# OPMENT MANAGEMENT AGENDA

# THURSDAY 15 JUNE 2017 AT 7.00 PM COUNCIL CHAMBER, THE FORUM

#### **ADDENDUM SHEET**

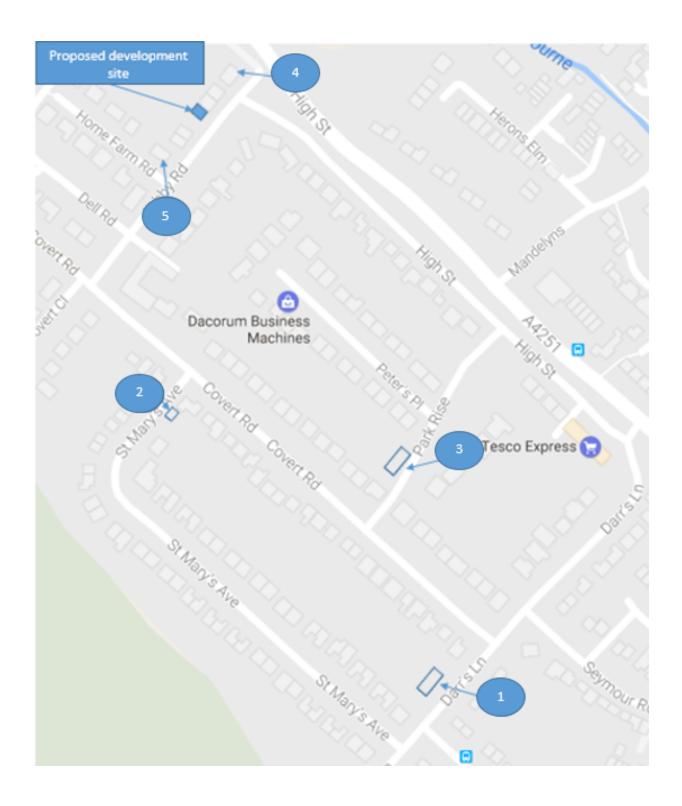
- Doesn't take into account the protected trees blocking light into the front window
- Doesn't note the downstairs bathroom
- Doesn't note the height difference of the window at the front, which is a lot smaller, compared with the side window

However I do appreciate that 4 Ashby Road does have dual aspect windows that mean that some light will be available but there are recent examples of good design that ensure light impact is kept minimal which should be pursued giving the house has had the right to light from the 2 side windows since the 1920's and as the report notes impacts this significantly/

#### 10 WRENSFIELD, HEMEL HEMPSTEAD, HP1 1RN

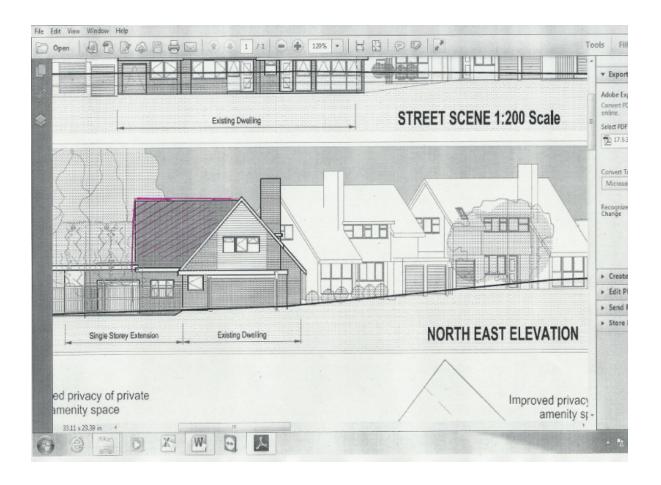
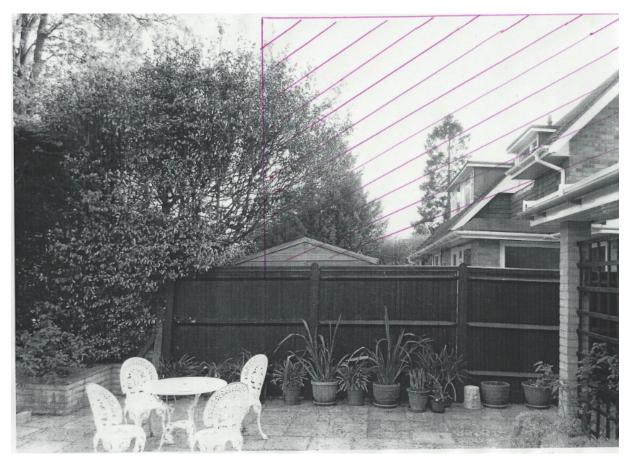
Now that clearer measurements have been provided, we note that the length of the 2-storey extension of plot 10a, adjacent to our boundary, is 3.4m at ground floor level.

However, we would stress that our primary concern is the height and mass of the 2-storey extension.

The existing property is, like 12 Wrensfield, being of the chalet style and the length of the new extension at first floor level will be approximately 5.4m. The ridge of the proposed extension will be approximately 8.4m. in length. The ridge heights of this row of houses (nos 6-16 Wrensfield inclusive) are high and the ridge of the 2-storey extension rises to the height of the ridge of the existing roof throughout its length.

As a consequence of the above and the close proximity of this new extension to our boundary and the rear of our house, we consider it to be overbearing. Furthermore, as the extension is located on the S-W boundary of our property, the degree of overshadowing, loss of natural light and diminution of amenity to our rear living rooms and patio are utterly unreasonable. To emphasise the above, we enclose an extract of one of the plans dated 30 May showing the N-E elevation of house 10a, together with a further copy of one the photographs of the rear of our house which were provided with our earlier letter and upon which we have drawn the extent of the 2-storey extension.
